ADDENDUM NO. 03

Project: 2024 Cypress Falls High School Renovation Cy-Fair Independent School District

Texas Arcadis Inc. Project No.: 202318

- 10. <u>Sheet CS2.05– Track and Field</u>
 - a) Contractor to perform artificial turf replacement and all associated work via an allowance.
- 11. <u>Sheet CS3.03 Utility Plan (Sheet 3 of 4)</u>

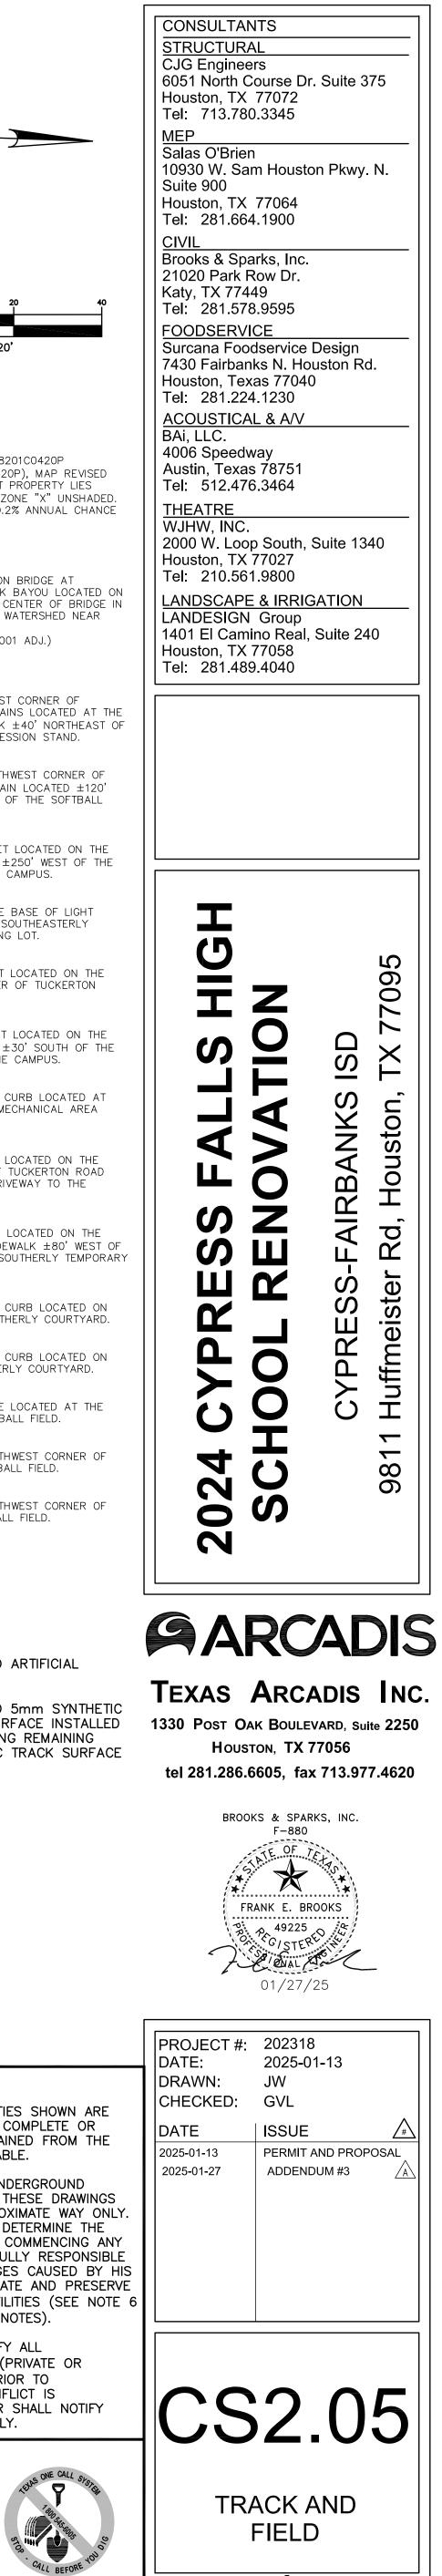
THEIR PROPOSAL THE RE-STRIPING OF THE TRACK AND FIELD EVENTS BETWEEN 2 AND 4 YEARS OF TRACK RESURFACING.

23 Jan 2025 10:53AM GregL F: \project\BROOK_SP\BAY\2290394 Cy-Fall HS Renovations\Civil\CS3.03 229-0394 UT 3.dwg Includes Xref(s): X-Topo.dwg; X-TB.dwg; X-Seal.dwg; Xsite.dwg; XUtI.dwg; XGR.dwg

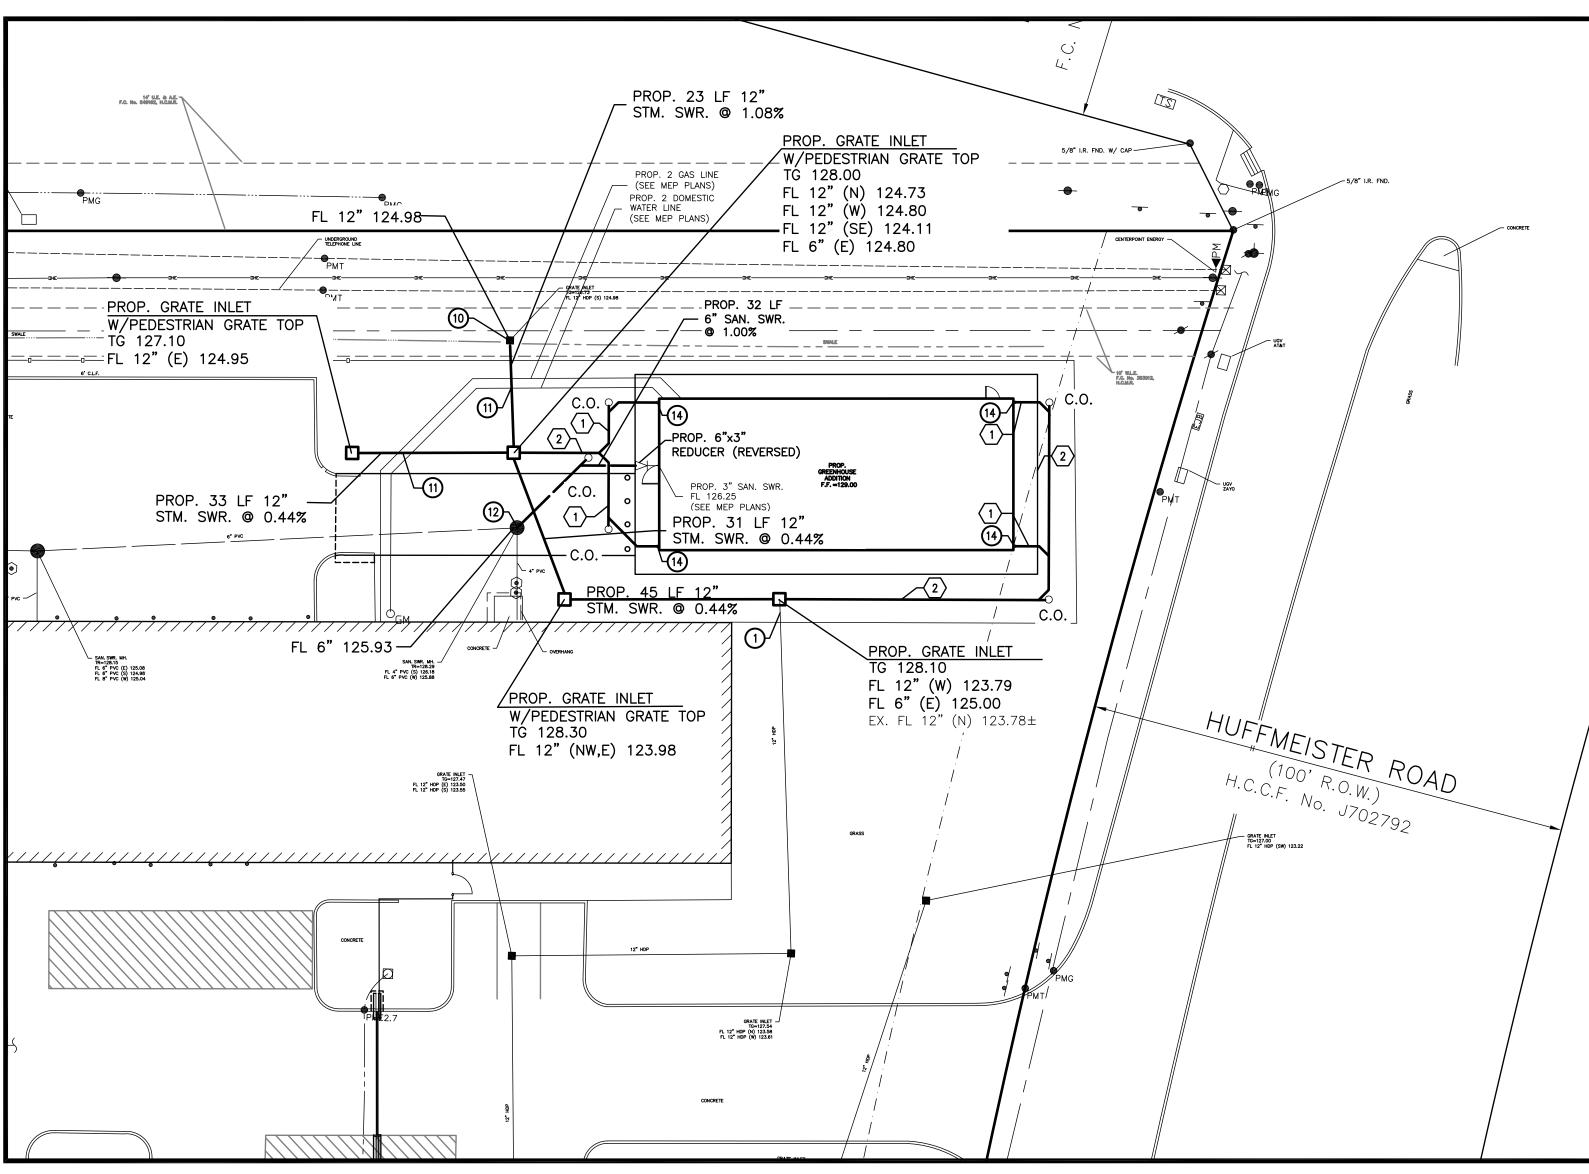
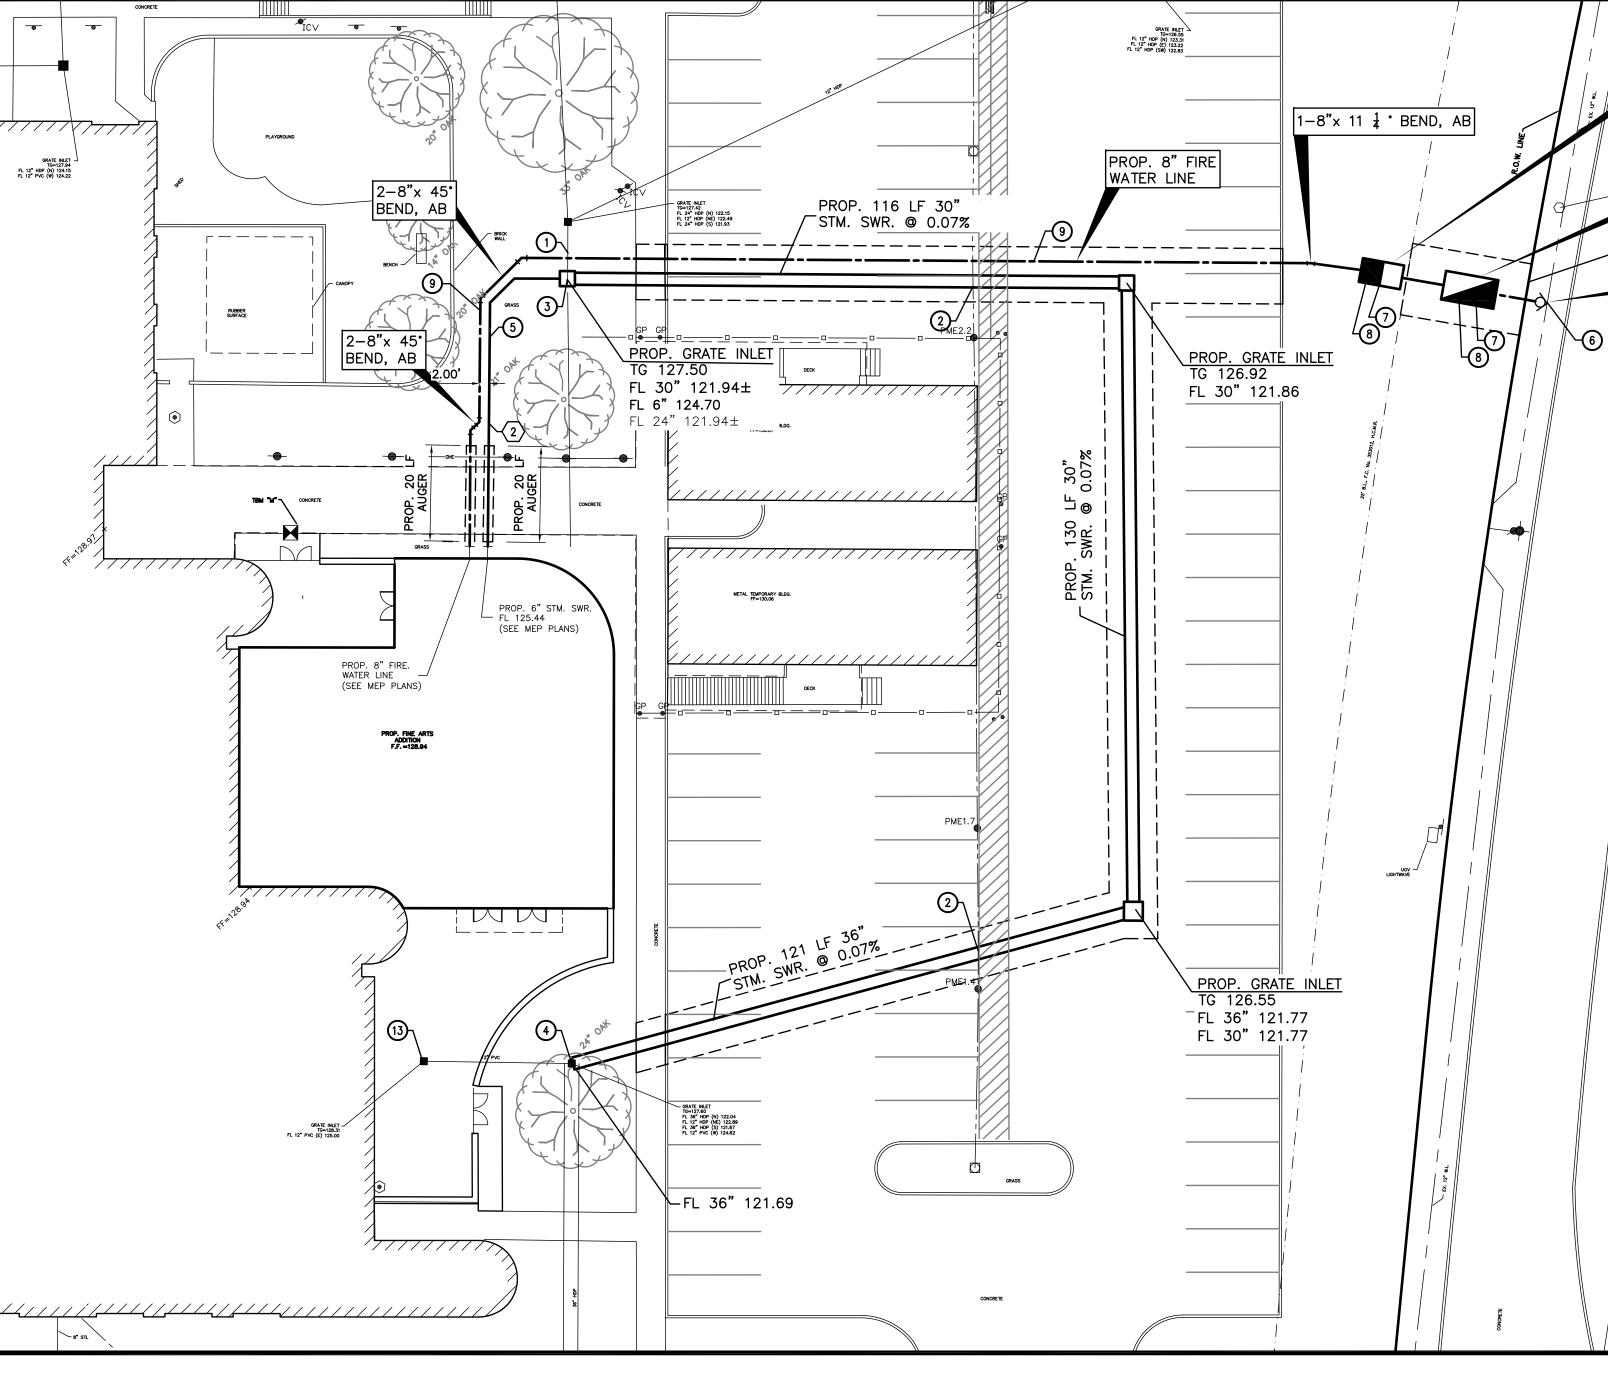
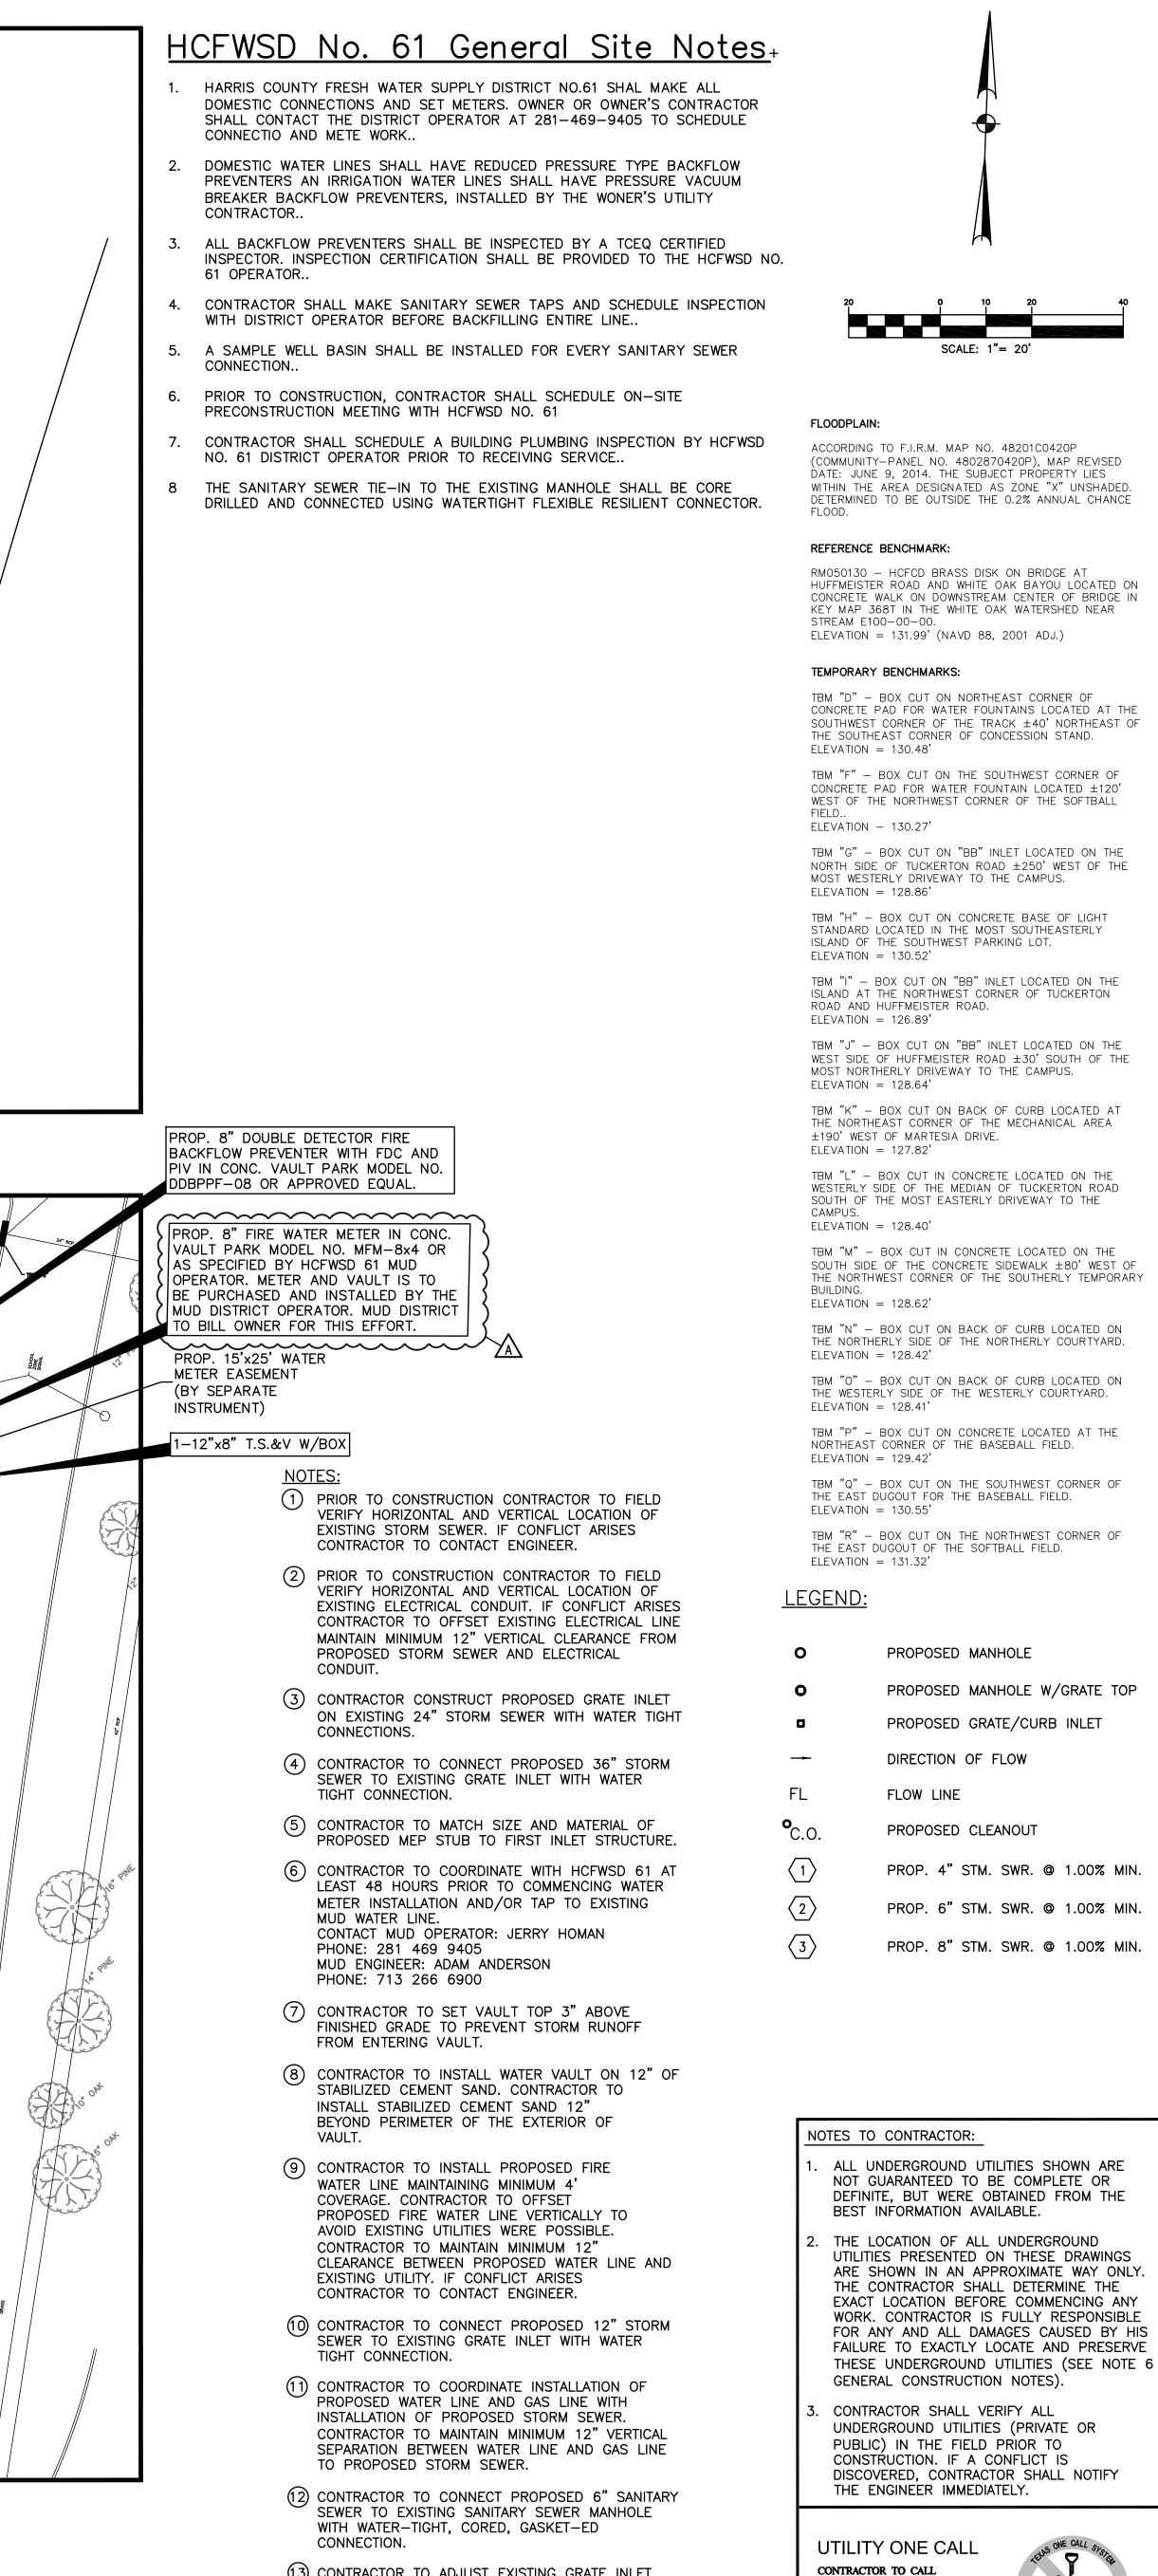
- a) Contractor to understand proposed water meter and vault is to be purchased and install by MUD district operator. MUD district to bill owner for this effort (see revised call on this sheet).

- 12. <u>Sheet CS3.04 Utility Plan (Sheet 4 of 4)</u>
 - a) Contractor to refer to detail provided for bollards at remote fire hose connections to sheet CS1.05 (see revised note 2 on this sheet).

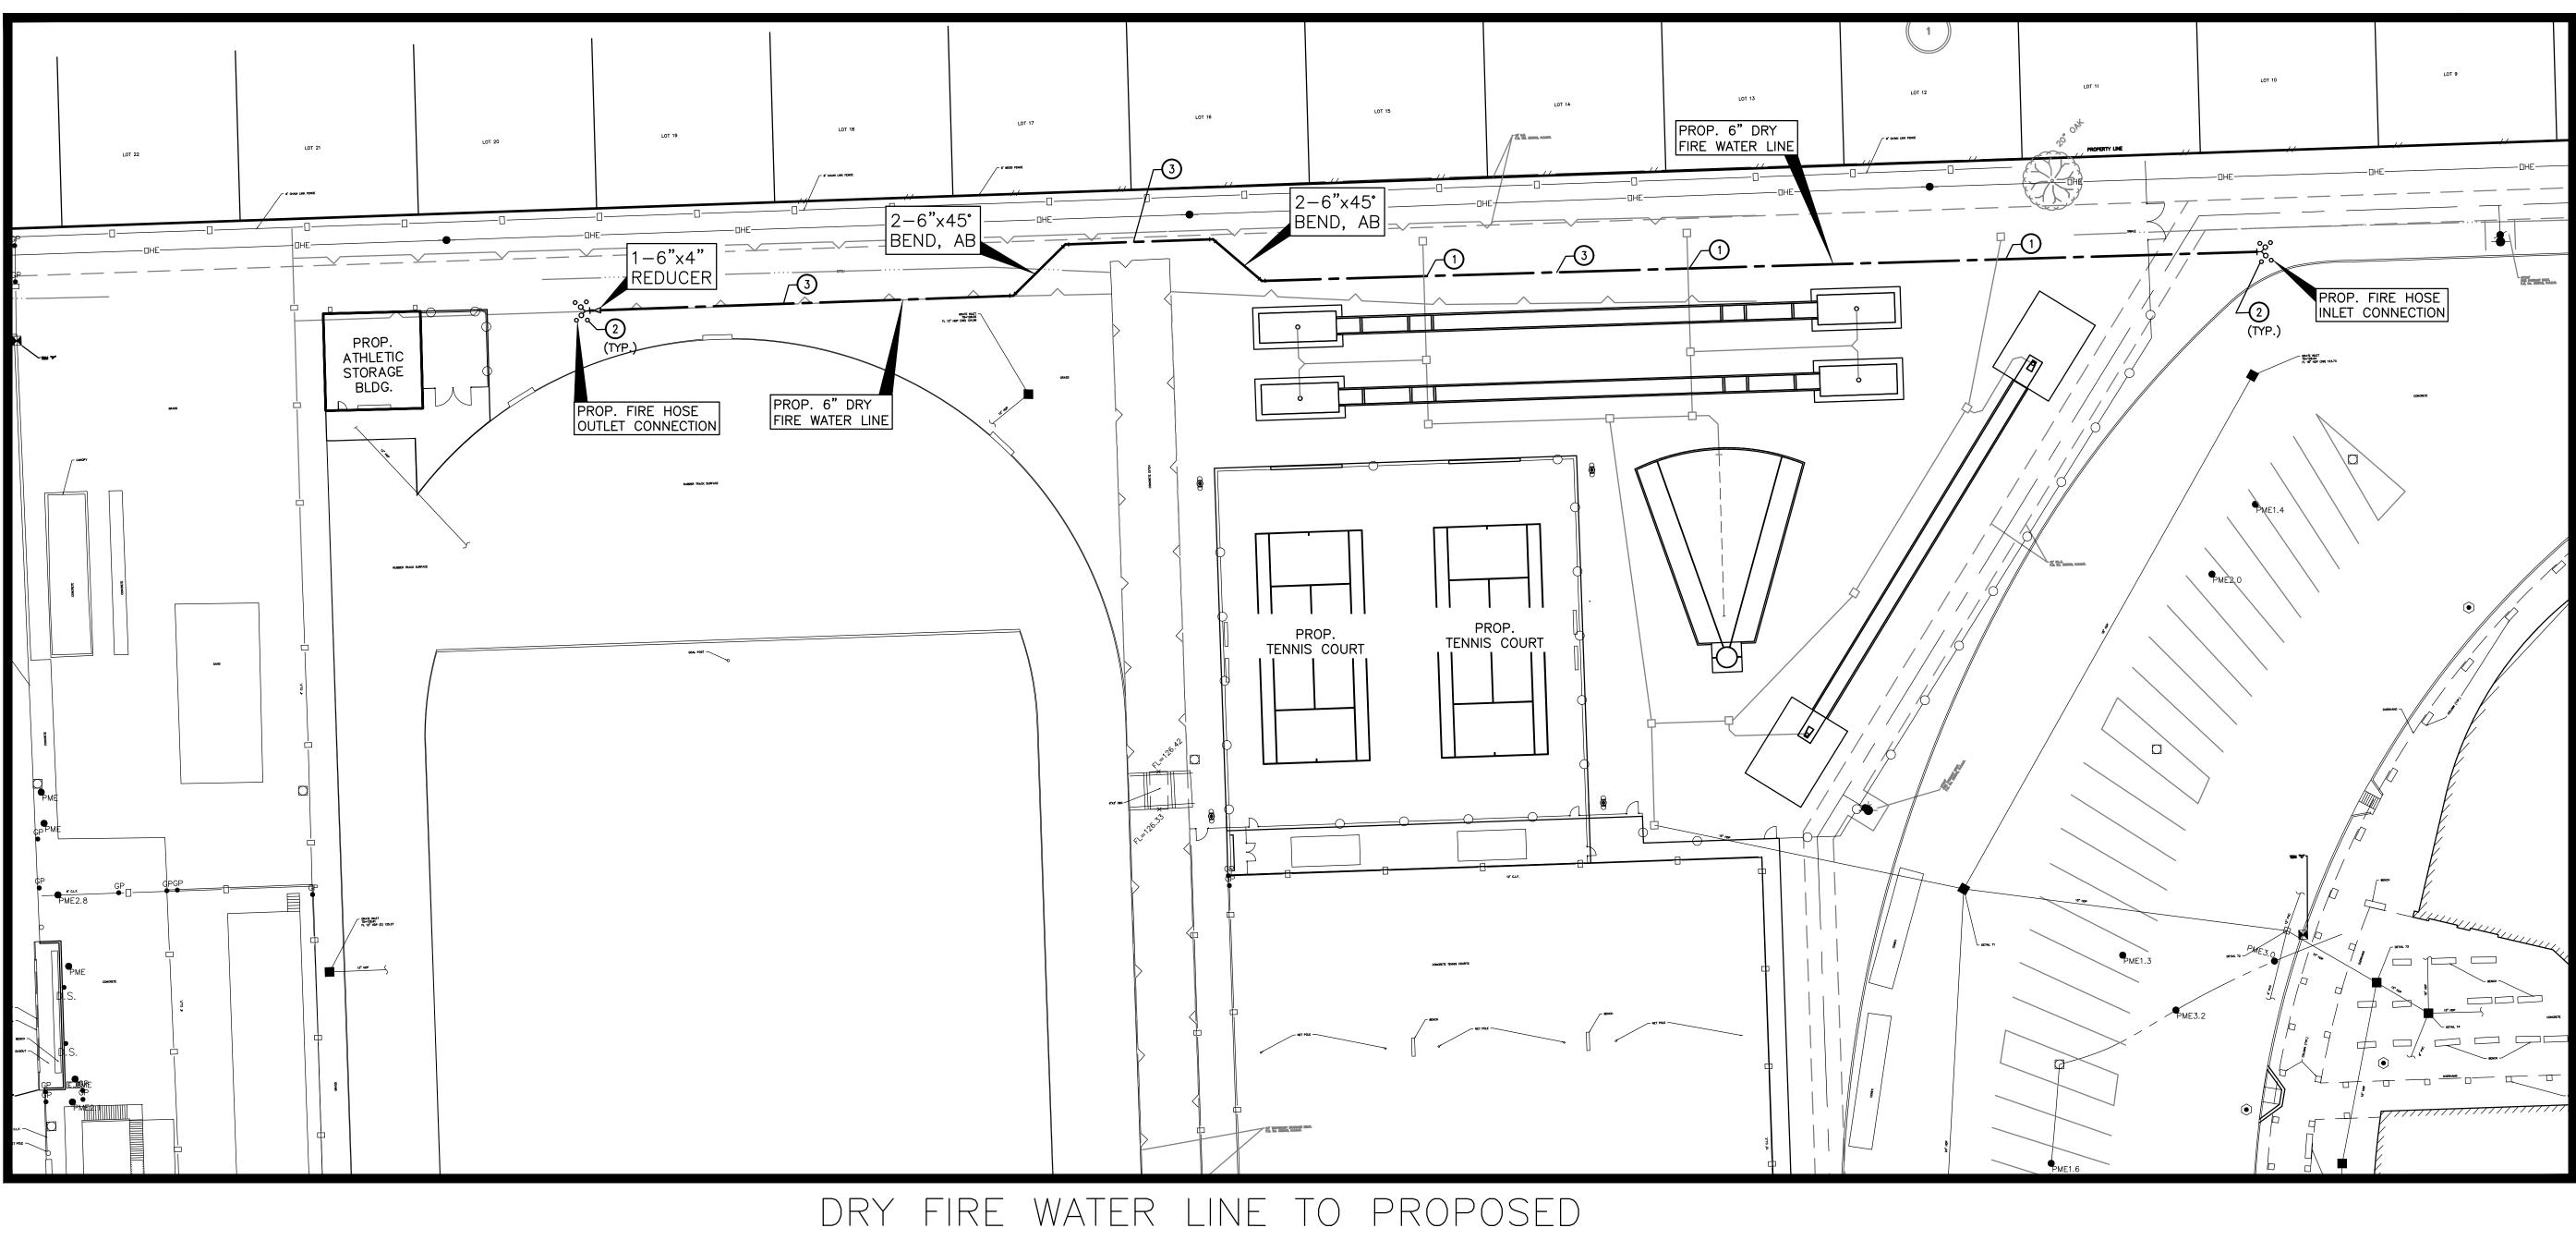
(2)PROPOSED BOLLARD (SEE DETAIL SHEE CS1.05).
